Notice to the Secretary of State for Transport,

SRO Objection

The Highways Act 1980
The Hertfordshire County Council
(A602 Improvements (Watton-at-Stone to Tonwell) Classified Road)
(Side Roads) Order 2019

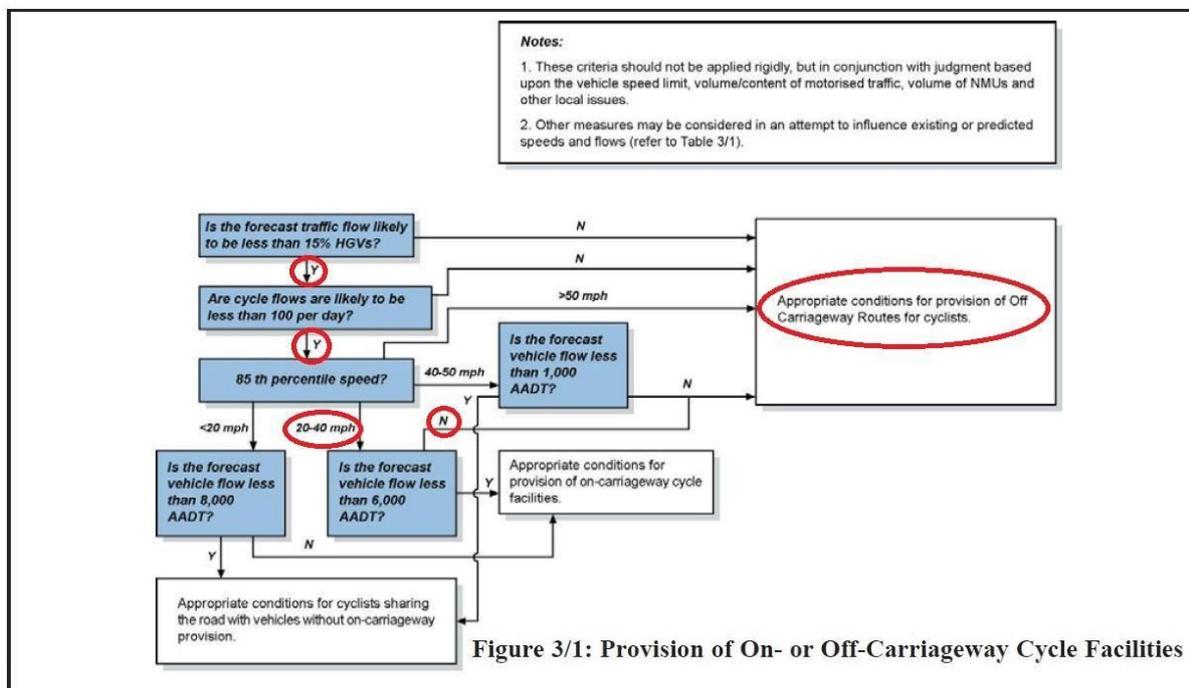
We have previously suggested that safety for NMUs could be significantly improved if the bridleway crossing could;

- a) be moved further north to improve sight lines*
- b) use the east side verge to connect to Bridleway 023*
- c) include a traffic island, allowing cyclists and walkers to cross the A602 in two stages.*

We stress the importance of having a two-stage crossing, for all cyclists and walkers and particularly for inexperienced cyclists and groups, enabling them to focus on one traffic lane at a time due to the volume and speed of traffic.
